Conceptual Review Agenda

Re: Centre for Advanced Technology - Office

Description of project: This is a request to construct a 28,000 square foot office building in the Centre for Advanced Technology (parcel #9723351002). The building will be 2 stories and will have 102 parking spaces. The site is located in the Employment (E) zone district. This proposal will be subject to Administrative (Type I) review.

Re: 2424 Kechter - Subdivision and Annexation

1 ARCHITECTURAL SITE PLAN
1" = 20'-0"

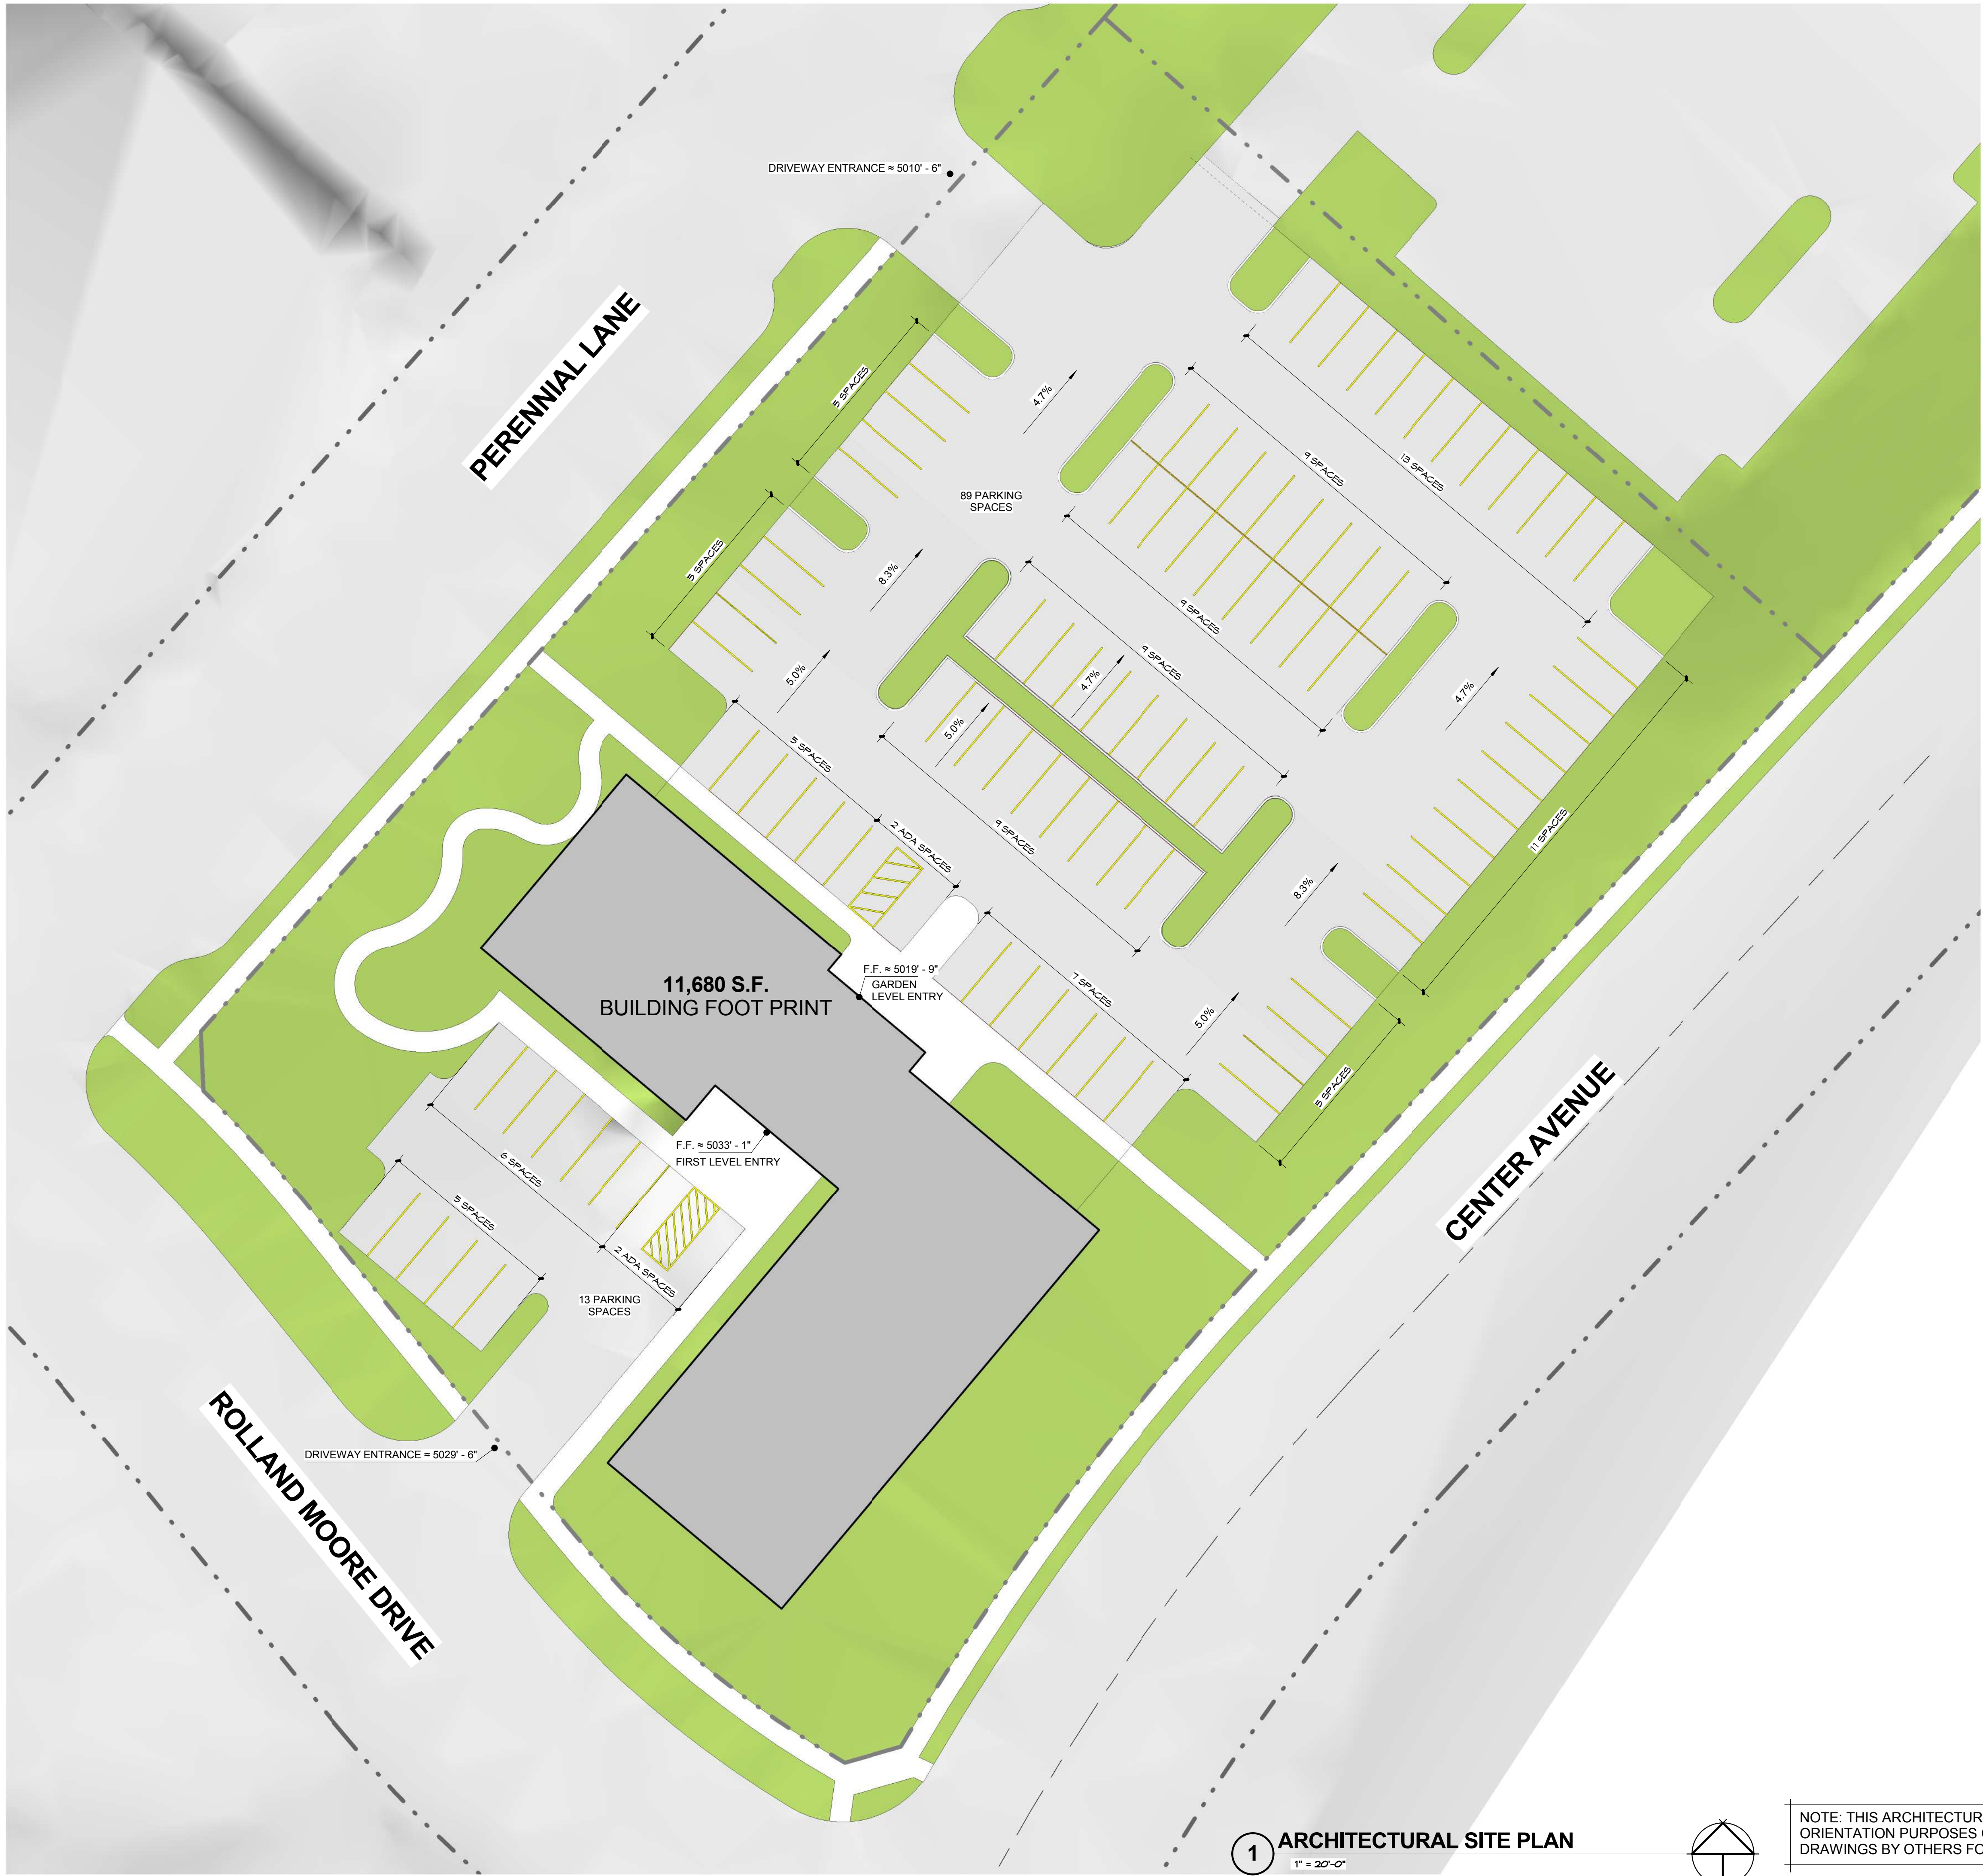
102 parking spaces would require 5 handicap spaces.

5. Access onto Rolland Moore Drive isn't preferred with its proximity to the Centre Avenue/Rolland Moore Drive intersection, and may not meet LCUASS requirements. Can this access be off of Perennial Lane or internally? The access, if allowed, would need to be directly across from the driveway access built with The Grove project.

2. The maximum parking allowed for a 28,000 sq. ft. office building is 84 parking spaces unless it is provided in a parking structure. The amount of parking shown on the site plan exceeds this maximum and would require an exception to the general office parking standards. The procedure for this exception can be found in section 3.2.2(K)(4) of the Land Use Code. You may also achieve the parking standards by following the alternative compliance guidelines in section 3.2.2(K)(3). Your other form of recourse is the modification process if you choose not to pursue the general office parking exception or alternative compliance measures.

Option 4

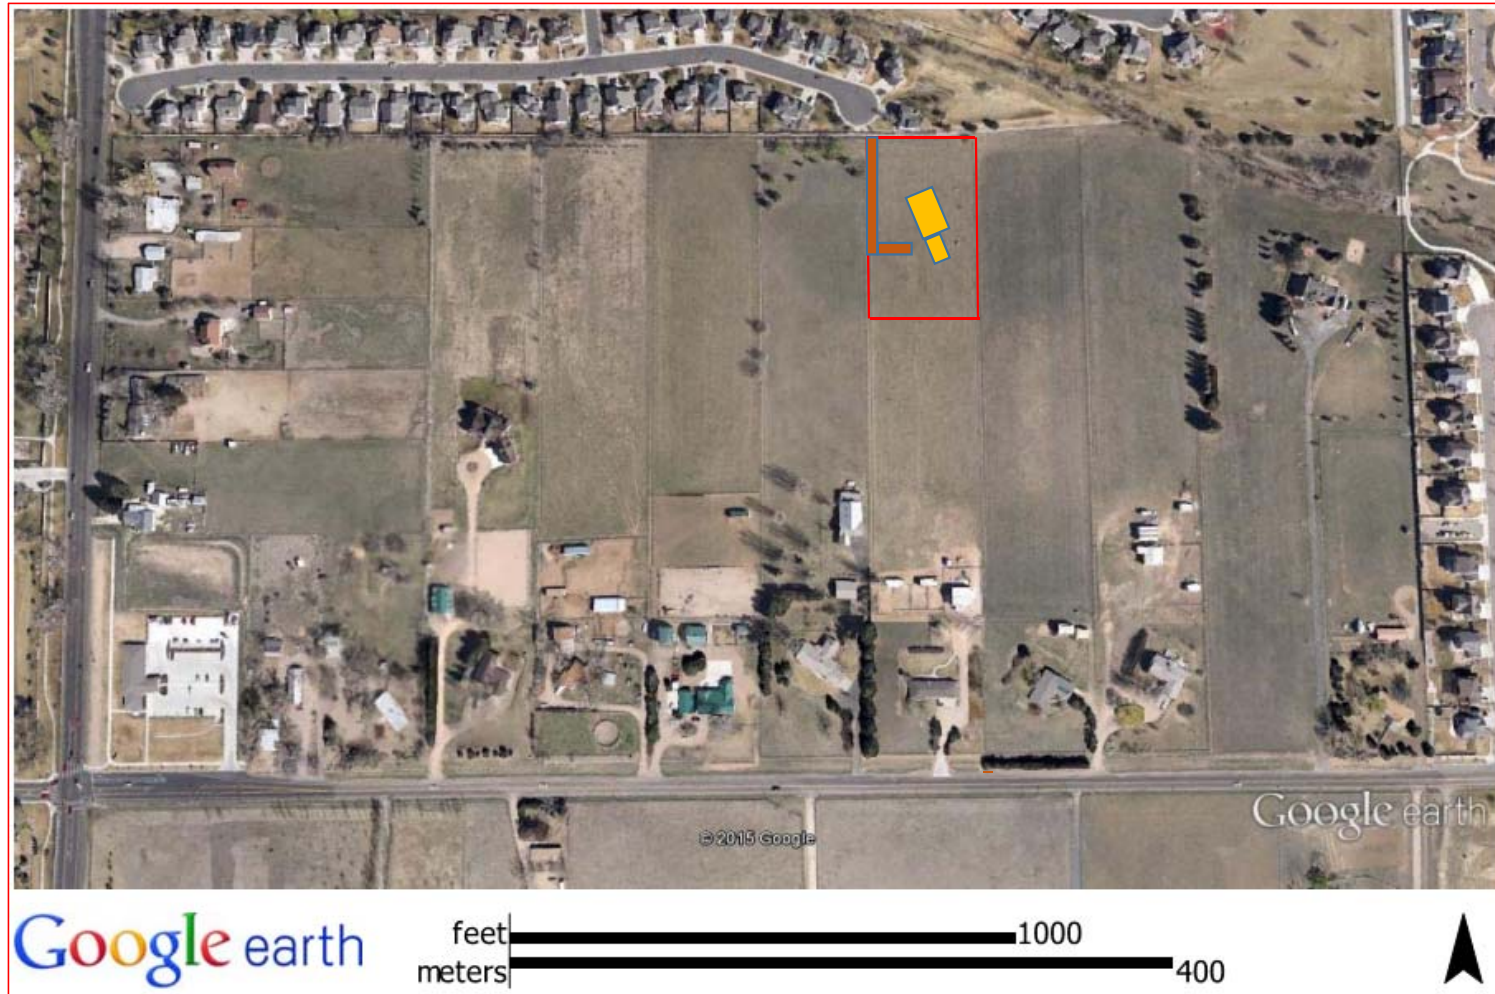
7. Option 4 that appears to show connectivity onto Sweetwater Creek Drive may not require Sage Creek Road per the previous comment, provided that the property does not exceed 660 feet in depth. Offsite right-of-way or easement may be needed from properties within the Stetson Creek PUD and a letter of intent from the property owner(s) would be required prior to a public hearing.
